1992 Corvette: Recall: Instrument Panel/Left Hand Lower Trim/Brake Pedal Interference

Subject: PRODUCT CAMPAIGN 92C10 - INSTRUMENT PANEL LEFT HAND LOWER TRIM PANEL/BRAKE PEDAL INTERFERENCE

Model and Year: 1992 CHEVROLET CORVETTE

Bulletin Number: 92C10 - (04/23/1992)

Figure 1

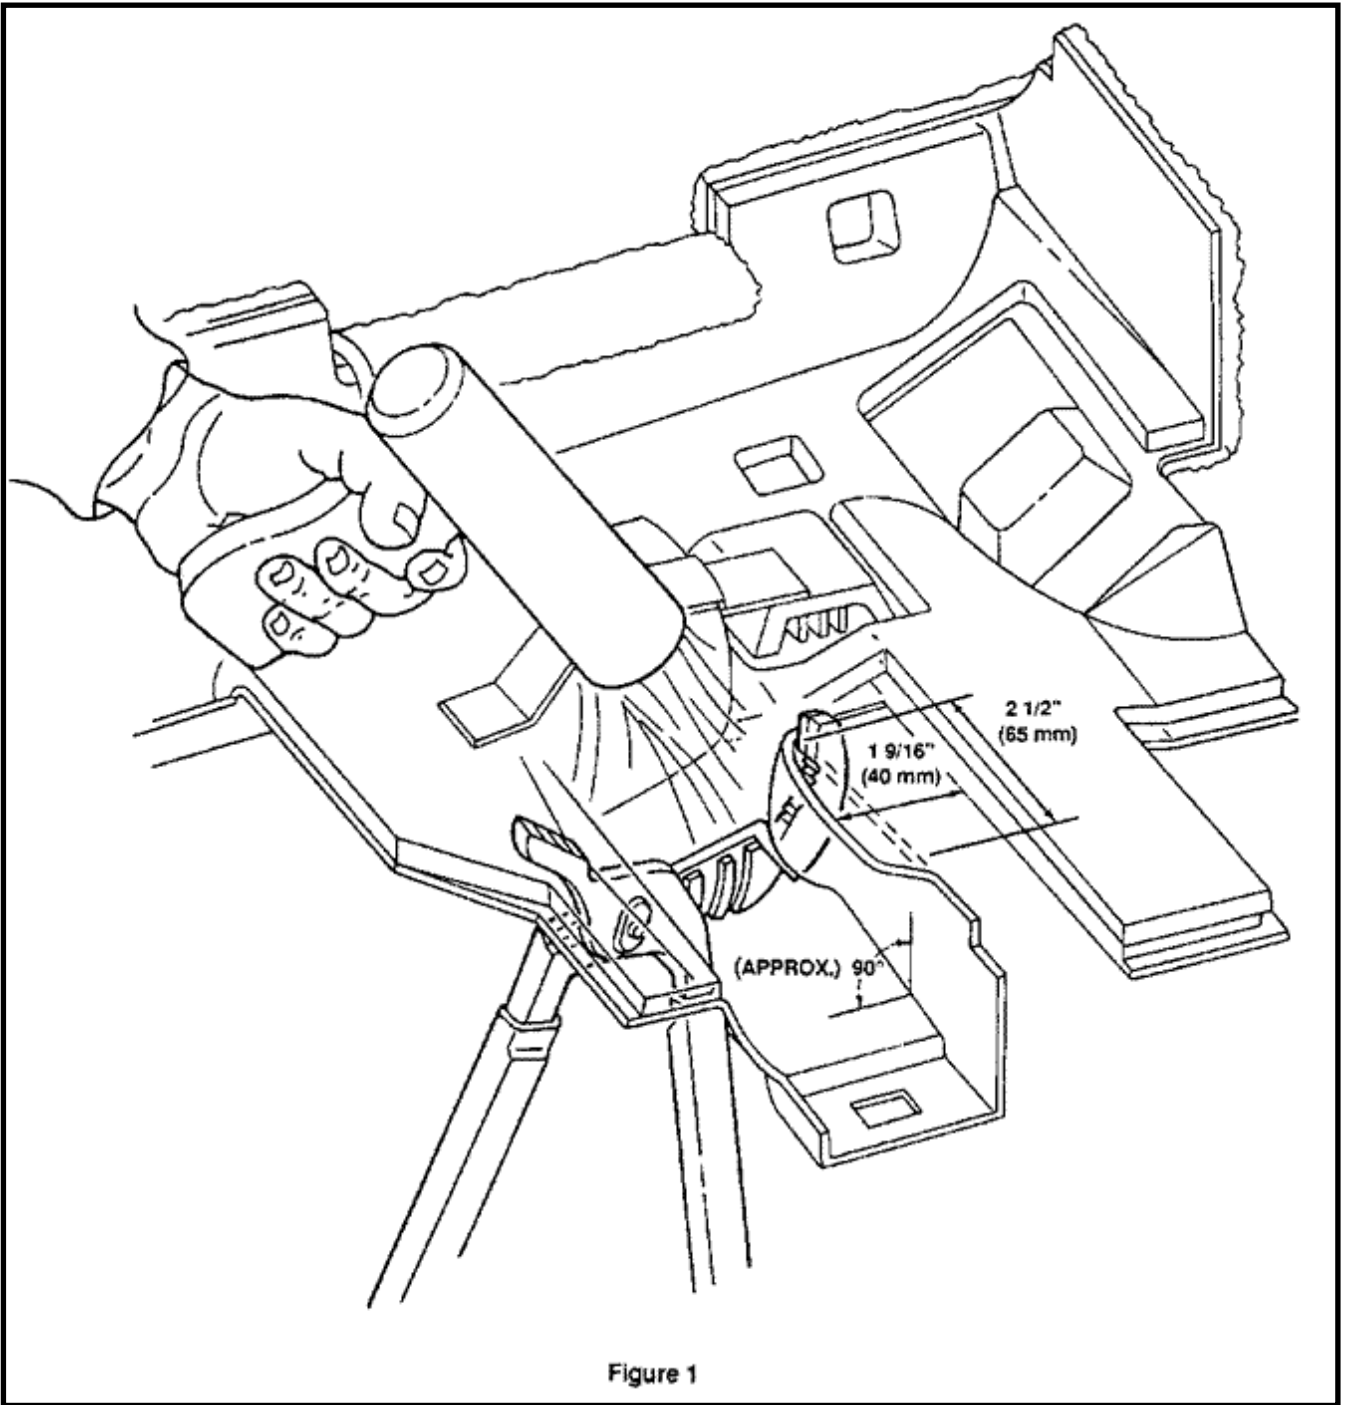
To prevent this condition from occurring, dealers are to inspect for proper clearance between the brake pedal arm and the instrument panel (I/P) left-hand lower trim panel. If clearance is not sufficient, the trim panel will be modified with a heat gun.

Attempt to pass an item approximately 2mm thick (such as a 2mm shim) between trim panel and brake pedal arm on both sides of pedal arm along entire length of pedal travel.

1. Remove I/P left-hand lower trim panel (per Preliminary Service Manual, Section 8C-33).
2. Lift away foam sound deadener from area shown in Figure 1 and tape out of way.
3. Using a heat gun, warm trim panel area shown in Figure 1. **USE CARE TO WARM COMPLETE AREA EVENLY.**
4. Using Channel Locks size 16 or larger, place near upper left-hand corner of I/P left-hand lower trim panel as shown in Figure 1. Quickly reform brake pedal opening to configuration and dimensions indicated in Figure 1. If necessary, Channel Locks may be moved downward during initial reforming and/or steps 3 and 4 may be repeated to obtain minimum clearance of 2mm between brake service pedal arm and I/P left- hand lower trim panel.

Notice: To lessen Channel Lock imprint, place smooth shim stock or aluminum face cover between Channel Lock face and warmed surface of I/P left-hand lower trim panel.

5. Reinstall I/P left-hand lower trim panel. Remeasure clearance between trim panel and brake pedal arm along entire length of pedal travel, using "INSPECTION" procedure on page 2.
6. Install Campaign Identification Label.
